INSPECTION REPORT
Sedimentation Structure
MW-B
Black Mesa Mine
Navajo County, Arizona
for
PEABODY COAL COMPANY

Dames & Moore
10139-011-22

SITE PLAN
MW-B

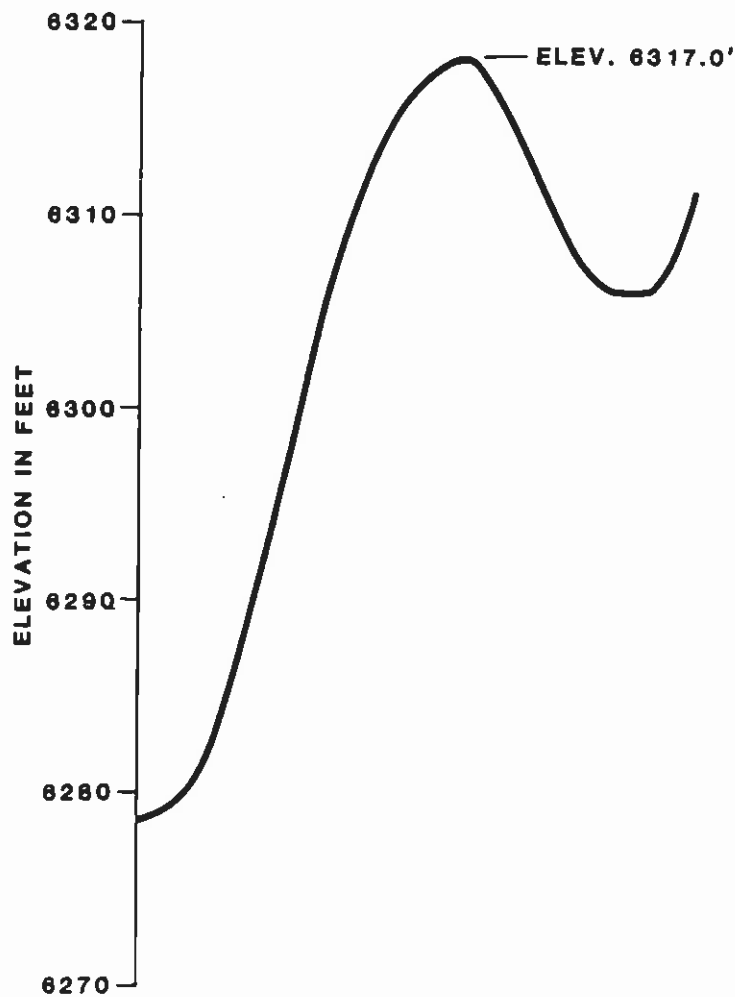
The inspection of Structure MW-B indicated that the geotechnical problems consist of rill and gully erosion on the downstream slope and a steep and uneven downstream slope. Correction of erosion is considered a periodic maintenance task and does not require remedial action. The downstream slope is uneven due to either lack of fine grading after initial construction or shallow surficial slope failures. The downstream slope should be flattened to 3.25 horizontal to 1 vertical to meet stability requirements. This flatter slope was selected due to a foundation slope greater than 5 percent. The downstream toe of this embankment needs to be riprapped to protect the slope from undercutting by flows in the Moenkopi Wash.

The storage capacity and spillway capacity of Structure MW-B are adequate; however, the spillway does not have an adequate outflow channel or adequate erosion protection. The proposed embankment relocation provides the opportunity to construct a new spillway and outflow channel in a location that minimizes the difficulties in providing adequate erosion protection. A trapezoidal outflow channel constructed along the alignment B-B' shown in Plate 1 will have a much flatter slope than a channel at the existing spillway location. The channel profile is shown in Plate 4 and the

required dimensions are shown in Plate 5. Both the spillway and outflow channel should be protected against erosion using geotextile and gravel as shown in Plate 5.

EXISTING
MAXIMUM CROSS-SECTION
A-A'
MW-B

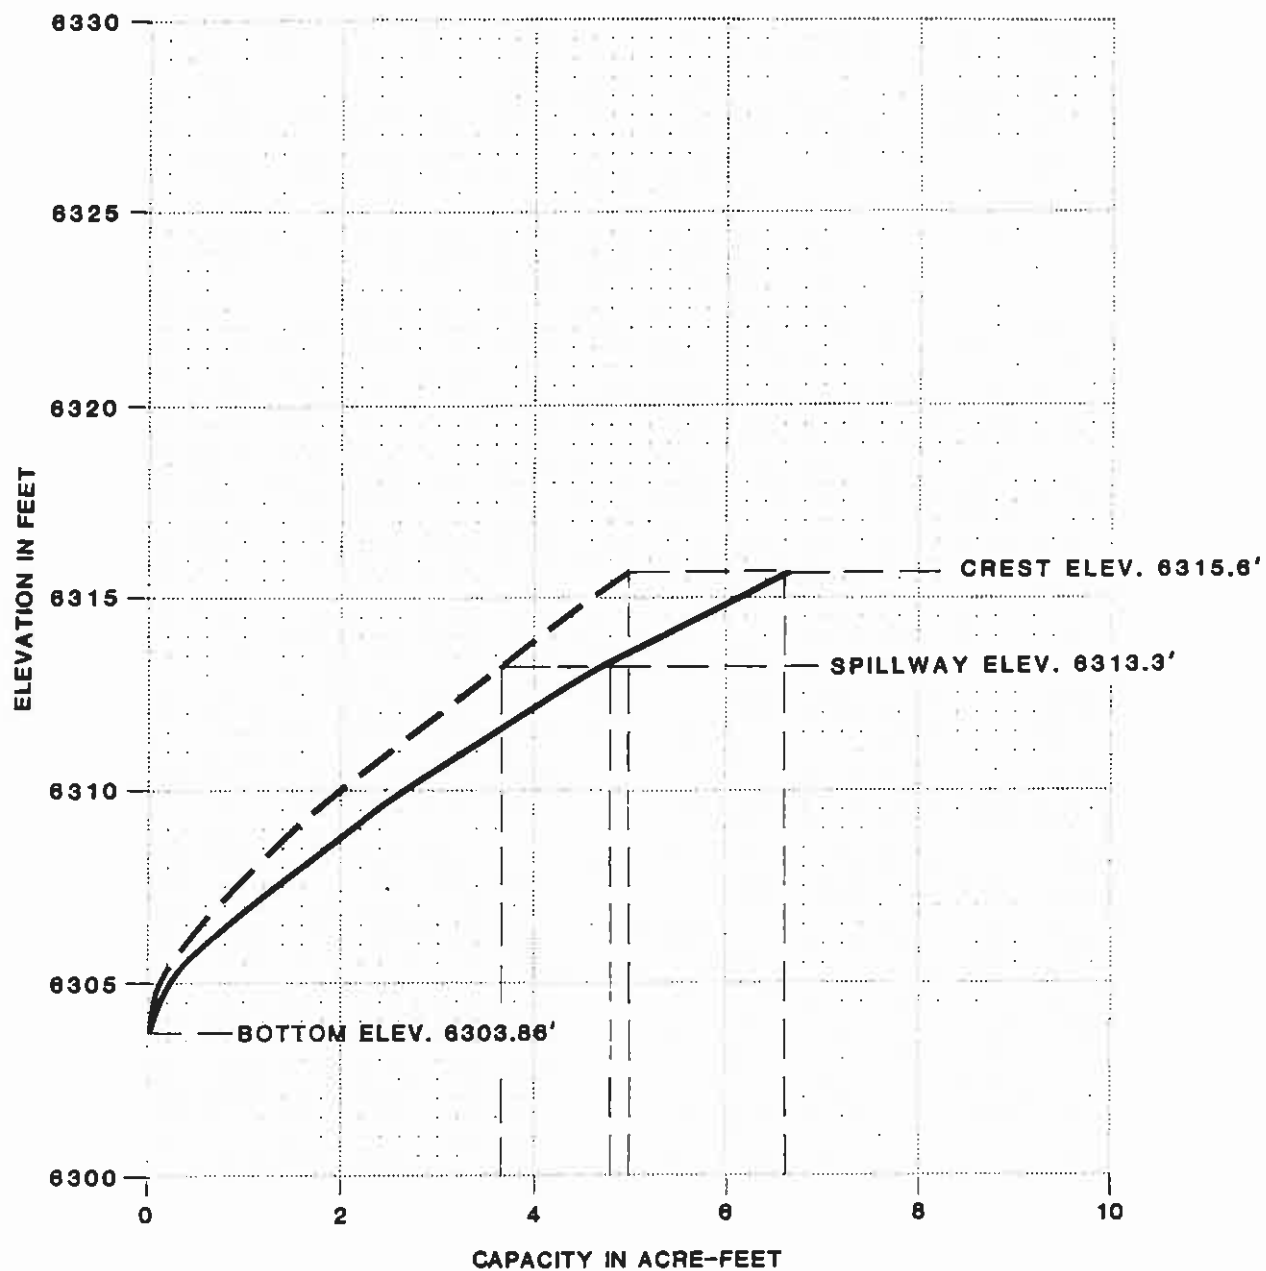
The MW-B embankment is lower in height; however, the downstream slope is steeper than the category standard; therefore, the embankment has factors of safety less than the design minimum.

VOLUME-ELEVATION CURVE MW-B

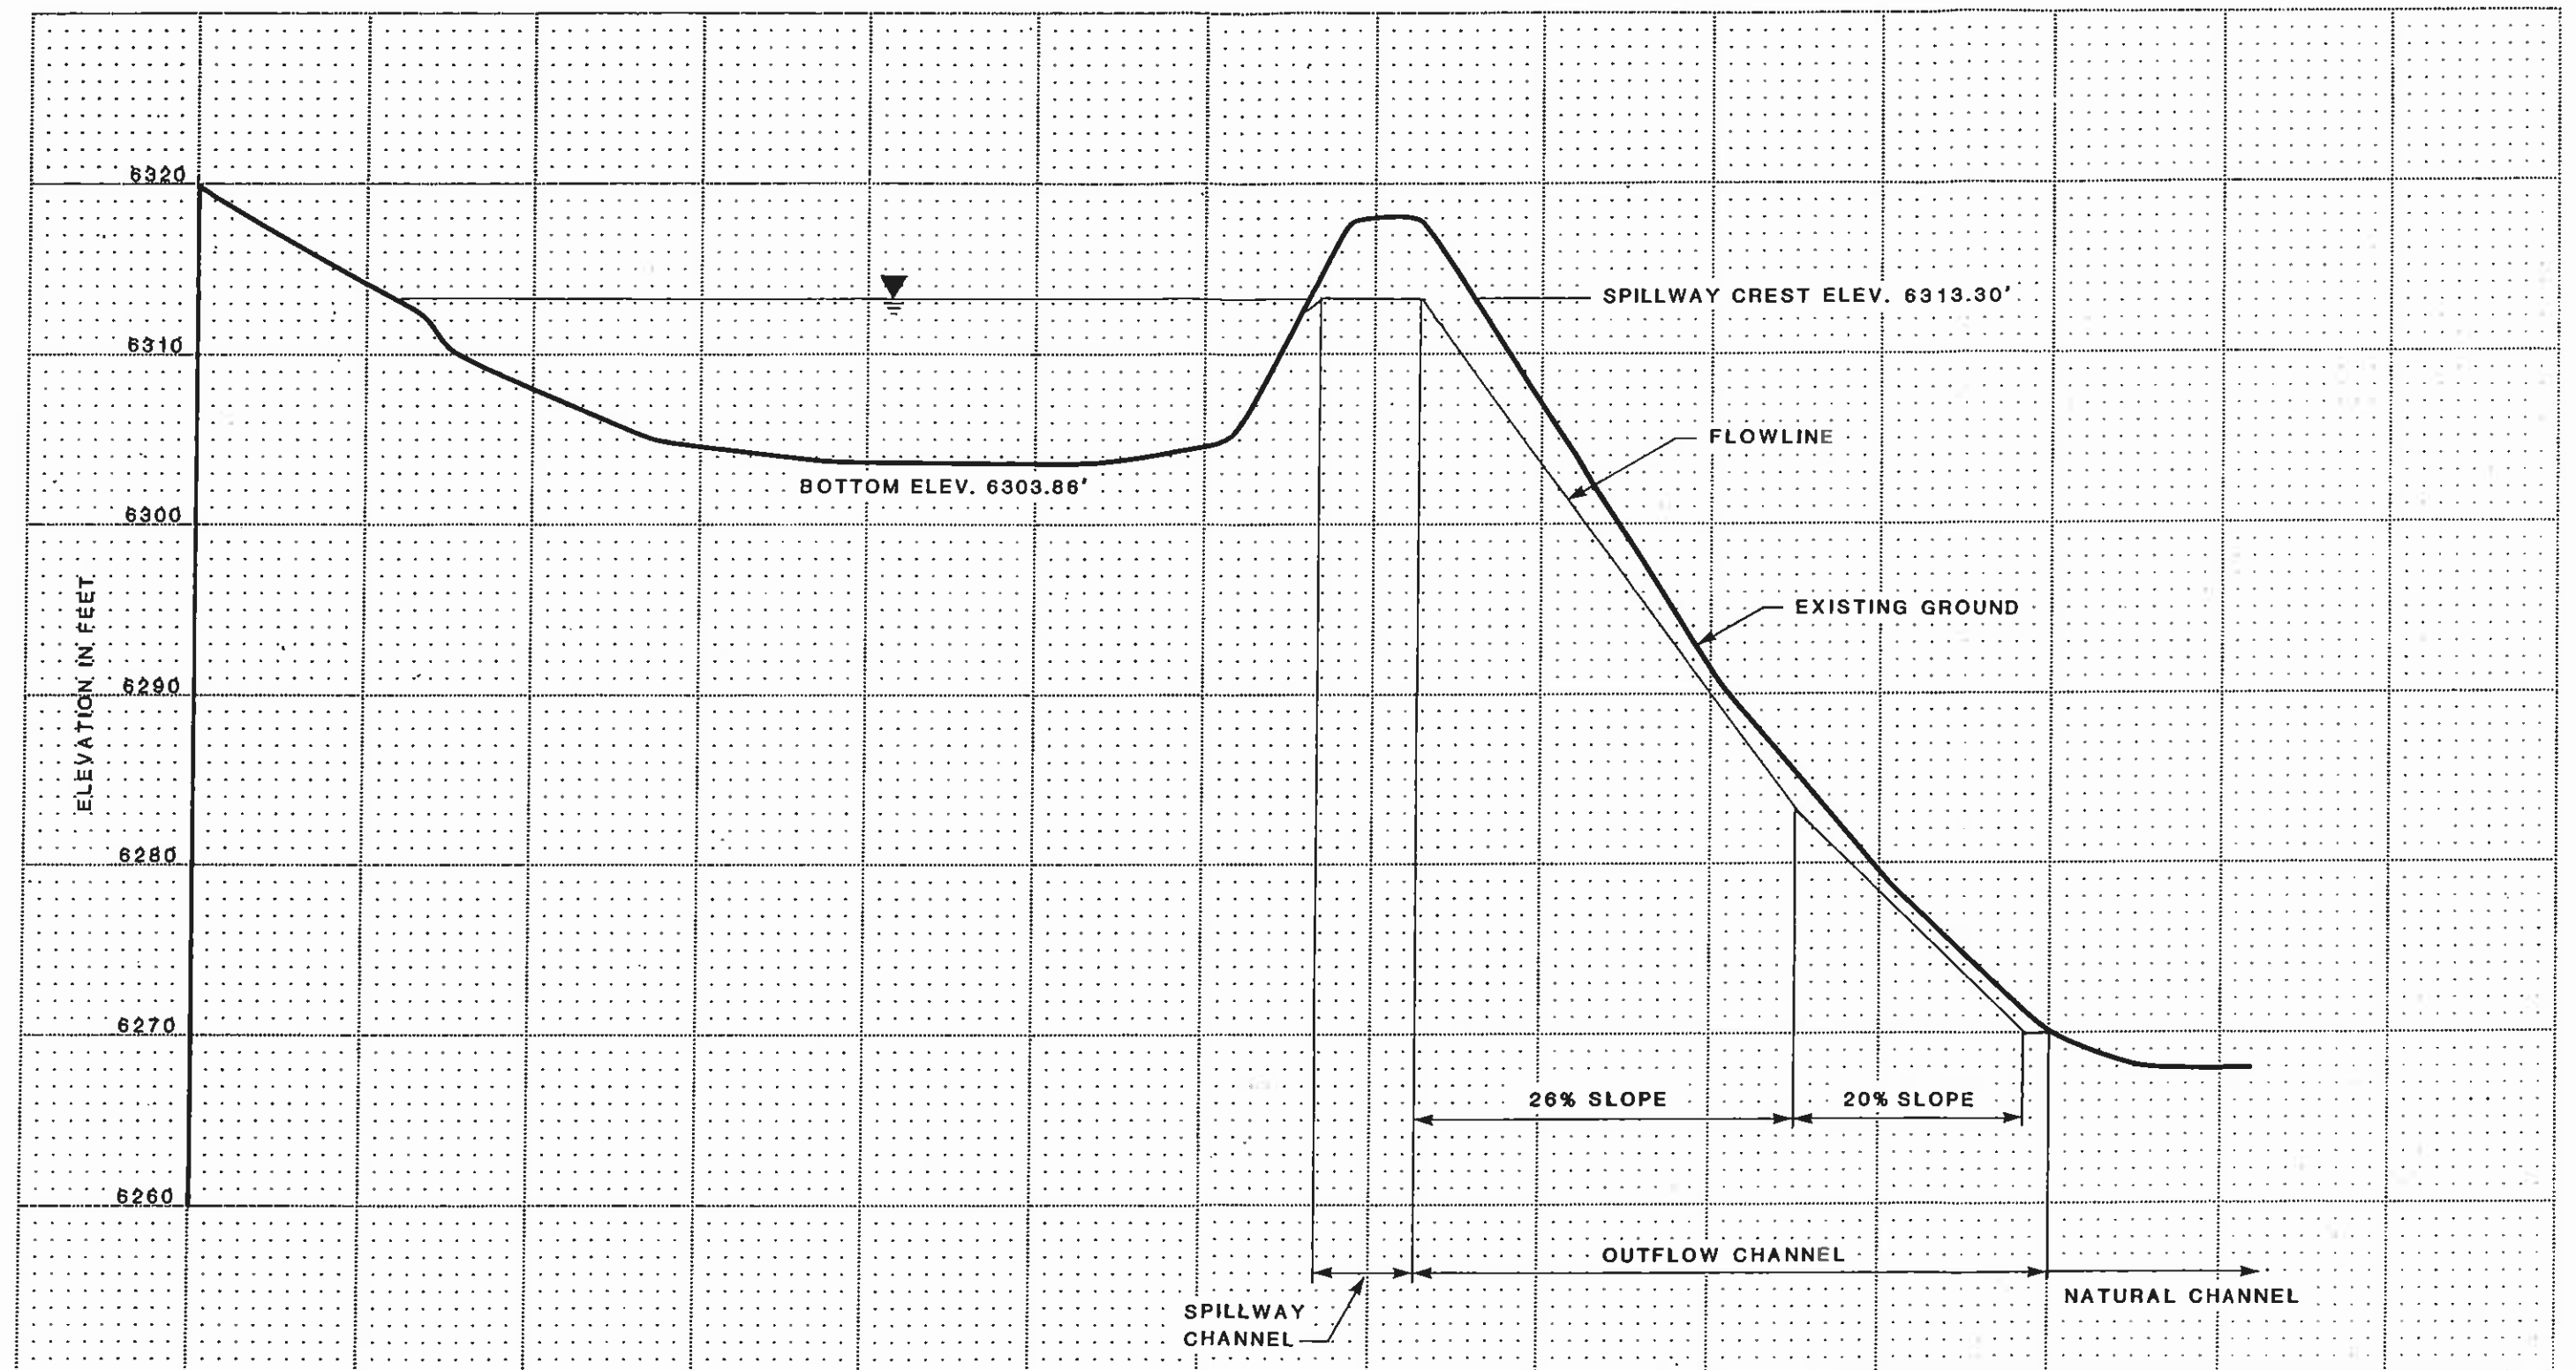
Relocating the embankment reduces the storage capacity. The analysis of these conditions is summarized in the following table.
